Well Name: GORDON	Well Location: T27N / R10W / SEC 22 / NESE / 36.557434 / -107.877136	County or Parish/State: SAN JUAN / NM
Well Number: 1R	Type of Well: CONVENTIONAL GAS WELL	Allottee or Tribe Name:
Lease Number: NMSF077952	Unit or CA Name:	Unit or CA Number:
US Well Number: 3004523764	Operator: HILCORP ENERGY COMPANY

Notice of Intent

Type of Submission: Notice of Intent	Type of Action: Plug and Abandonment
Date Sundry Submitted: 01/20/2025	Time Sundry Submitted: 06:15
Date proposed operation will begin: 02/01/2025

HILCORP ENERGY COMPANY
GORDON 1R
P&A NOI

GORDON 1R - PROPOSED WELLBORE SCHEMATIC

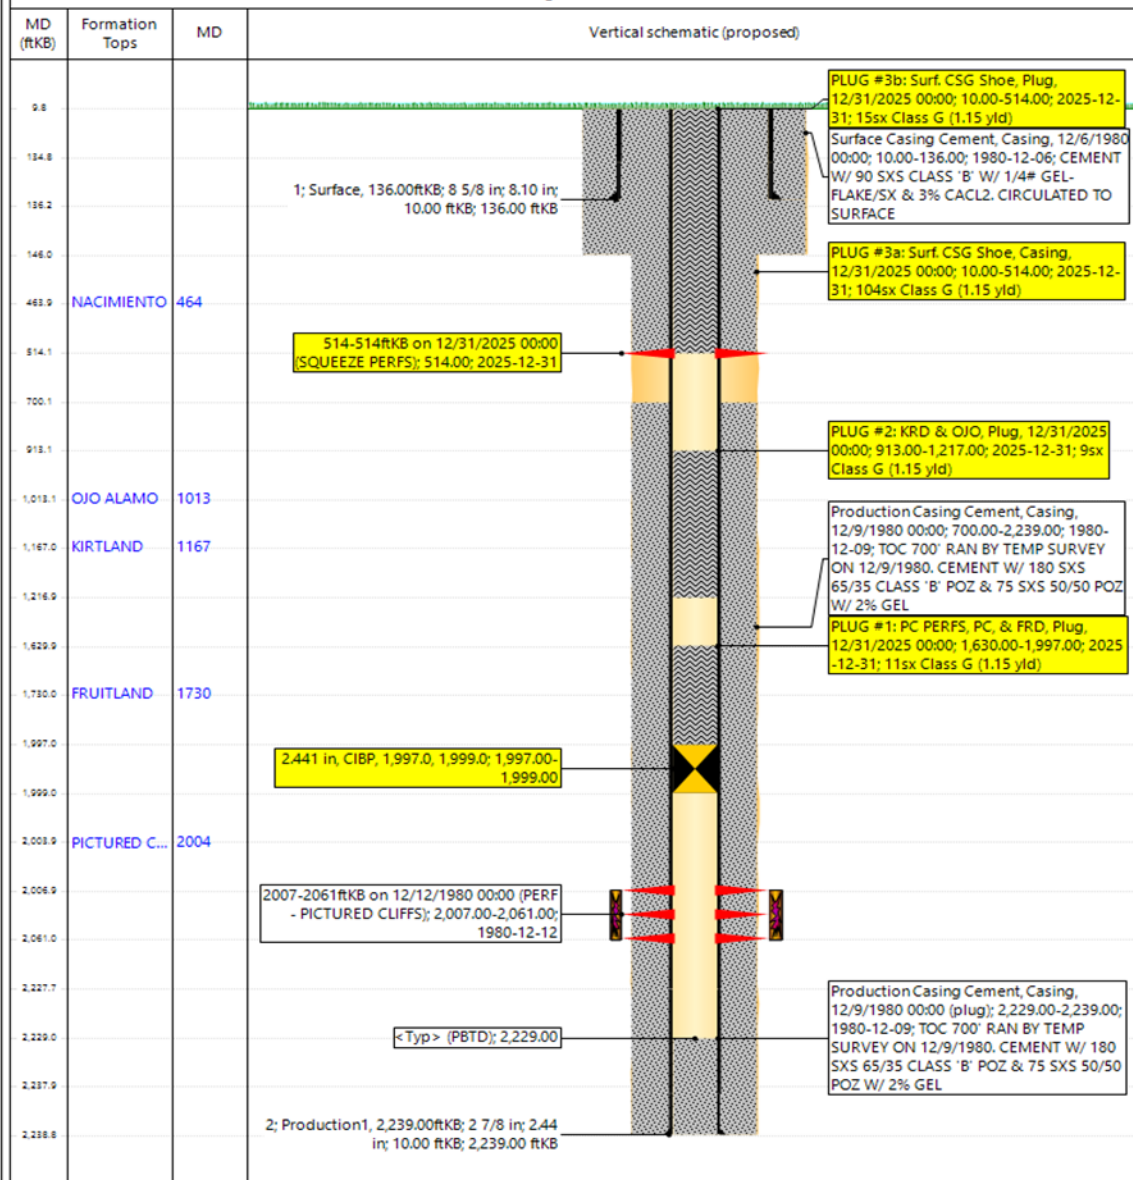
Remarks: Please adjust plugs to account for BLM-picked formation tops.

Created By	Condition	Condition Date
mkuehling	NMOCD agrees with BLM call on formation tops - extend plug one to 50 feet below PC top - Notify NMOCD 24 hours prior to moving on - monitor string pressures daily report on subsequent - submit all logs prior to subsequent	2/11/2025
